Product Change Notification / SYST-26JLSD716

ERRATA - PIC18F65/66K40 Family Silicon Errata and Data Sheet Clarification

PIC18(L)F65/66K40 Family Silicon Errata and Data Sheet Clarification

The PIC18(L)F65/66K40 devices that you have received conform functionally to the current device data sheet (DS40001842D), except for the anomalies described in this document.

Figure 38-10: ADC Conversion Timing (ADC Clock F_{OSC}-Based)

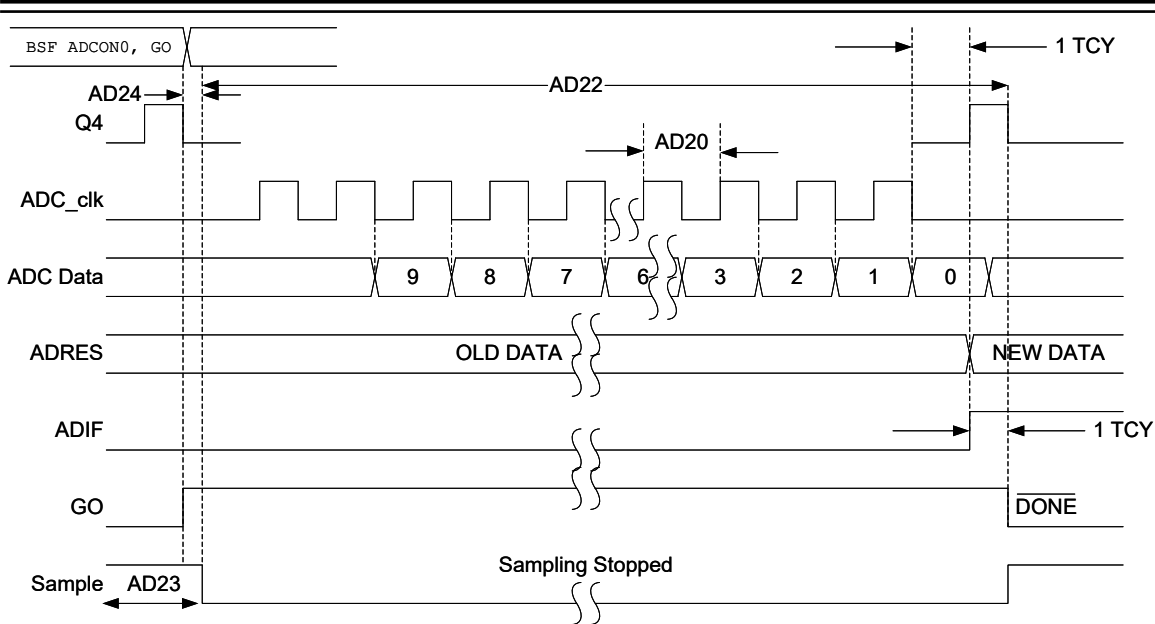
Refer to the images below for corrections of Figure 38-10 and Figure 38-11. Previously, the parameter numbers were incorrect.
